Technical Bulletin: 2011-XXR
2011 FJR13AAS/ AASC
Factory Modification Campaign: Front Brake Switch

IDENTIFICATION PROCEDURE

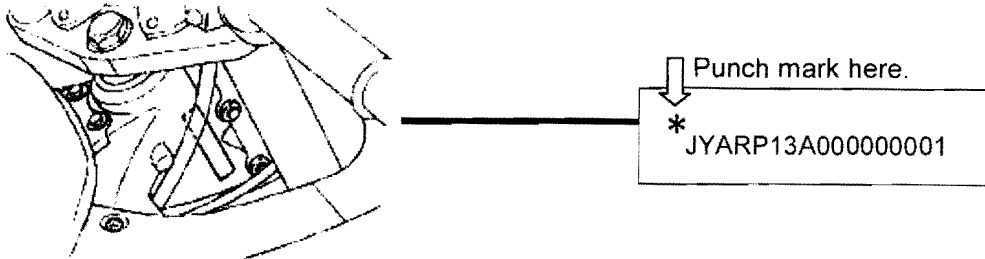
After modifying a unit, make a punch mark above the vehicle identification number (VIN) as shown in the illustration. Check for this punch mark if you encounter an unfamiliar unit. You can also check unit status on YDS or by contacting your Regional Technical Advisor.

Part Identification

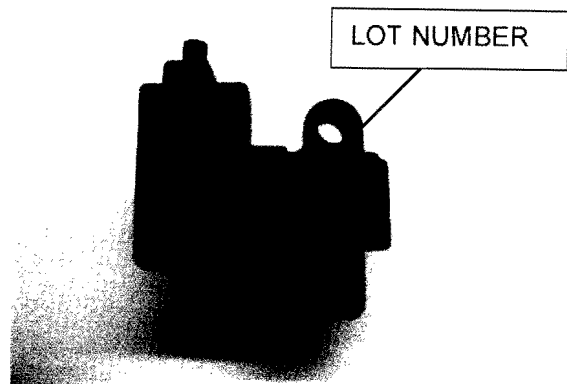
The lot numbers of defective parts are "0X15" through "1419." The lot numbers are a date code as follows:

Therefore, the 0X15 example shown in the photo is October 15th, 2010, production (needs replacement). The lot numbers of corrected parts begin with "1420," which is April 10, 2011 or later.

Be sure to check your dealership's inventory. If you have any affected Front Stop Switch Assembly parts in stock, return them to Yamaha using standard Quality Assurance procedures.
